VENDOR SERVICE PUBLICATION

SUBJECT: Oil Pump Impeller and Drive Replacement; AVCO Lycoming Service Bulletin No. 385C dated October 3, 1975 (attached).

Service Bulletin No. 385C
(Supersedes Service Bulletin No. 385B)
Engineering Aspects are
FAA (DEER) Approved

SUBJECT: Oil Pump Impeller and Drive Replacement

Figure 1. Interior View of Accessory Housing Showing Location of Cotter Pin in Oil Pump Idler Shaft

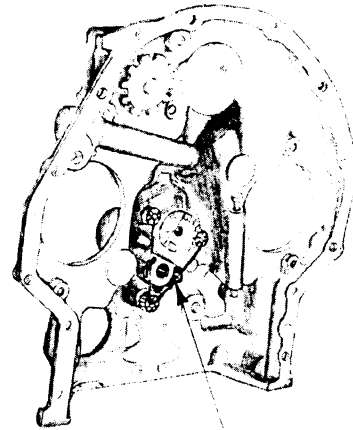
INSPECTION: Applicable remanufactured engines shipped after December 21, 1972 should be inspected to determine if this modification is required: first of all, if the engine log book indicates the engine has not been modified in accordance with Service Instruction No. 1230 or No. 1272, proceed to remove the accessory drive cover from the mounting pad at the lower right side of the accessory housing to obtain access to the area between the crankcase and the accessory housing. On some engines this accessory drive pad is not machined, in this event it will be necessary to remove either the left magneto or the *fuel pump to obtain access to the area between the crankcase and the accessory housing. Regardless of which accessory pad is used, determine if the oil pump idler gear is secured with a cotter pin at the location shown in figure 1. This can be accomplished using an inspection mirror, preferably an illuminated one. If the cotter pin is visible, it is unnecessary to perform the modification required by this bulletin.

IF IDLER SHAFT IS SECURED WITH A COTTER PIN AT THIS LOCATION MODIFICATION IS NOT REQUIRED

Figure 2. Oil Pump Drive Assembly

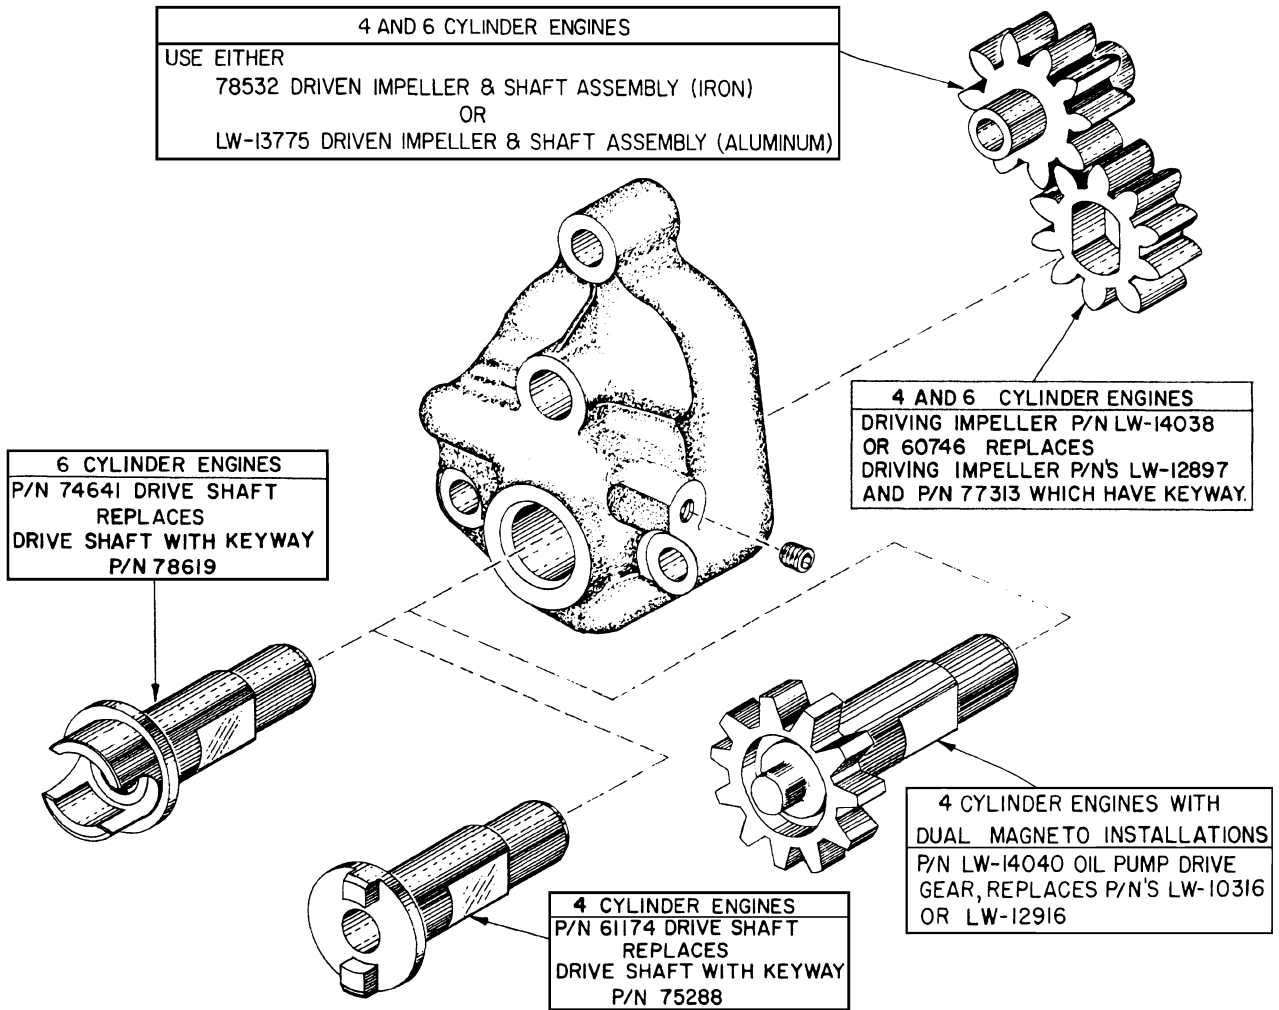
This modification consists of replacing the oil pump drive shaft and drive impeller to eliminate the Woodruff key drive which has proven to be the cause of excessive wear in the keyway of the hardened drive impeller. Therefore, it is recommended that all of the applicable engines listed in the chart, as well as any others that may have been modified in accordance with Service Instruction No. 1272, use the following procedure for parts replacement.

3. Reassemble the oil pump using the new drive shaft and drive impeller supplied with the kits shown in the following "Parts Data" section. See figure 2. Be sure all of the parts are lubricated thoroughly during assembly.

- LW-14131 Oil Pump Shaft Replacement Kit (4 cylinder engines)
 consists of: (1) 61174 oil pump drive shaft, (1) LW-14038 or 60746 drive impeller

- LW-14132 Oil Pump Shaft Replacement Kit (4 cylinder, dual drive magneto engines)
 consists of: (1) LW-14040 oil pump drive gear, (1) LW-14038 or 60746 drive impeller

- LW-14133 Oil Pump Shaft Replacement Kit (6 cylinder engines)
 consists of: (1) 74641 oil pump drive shaft, (1) LW-14038 or 60746 drive impeller
